RESOURCE MANAGEMENT ACT 1991

Submission under the Resource Management Act 1991 on Private Plan Change 46 - 160 Bangor Road, Selwyn District Plan

Attachment:

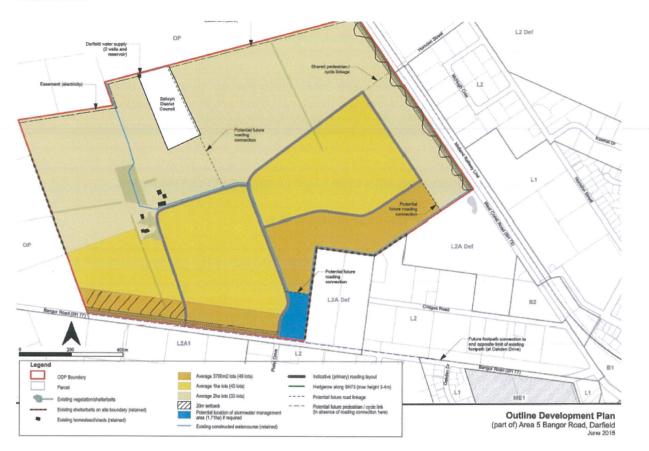
10. Remove higher density 3700m² lots between the western side if the proposed second SH77 road access to the western boundary of the proposed zone as per attachment. Replace these with 2ha lot density.

13. No direct property vehicle access to the zone from SH77 from the western side if the proposed second SH77 access road to the western boundary of the proposed zone. No direct property vehicle access to SH 73. That this explicit requirement be embedded in the rules and ODP.

Remove smaller lot density 8 no direct property vehicle road access to SH 77

No direct property vehicle access to
